**Affected Products - RACM150-S/F Series**

We herewith inform you that an EOL (end of life) notification from our fan supplier has forced us to change to a different fan model and this will increase the height of the fan and therefore the height of the product by 1.5mm.

Details about the change:

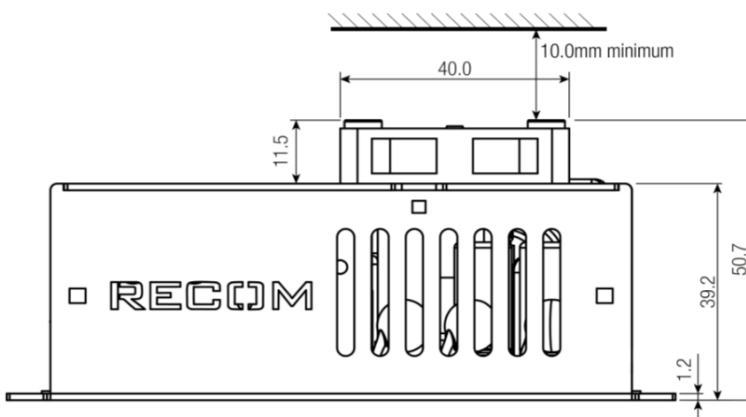
This change has no impact on the electrical specifications or reliability of the product.
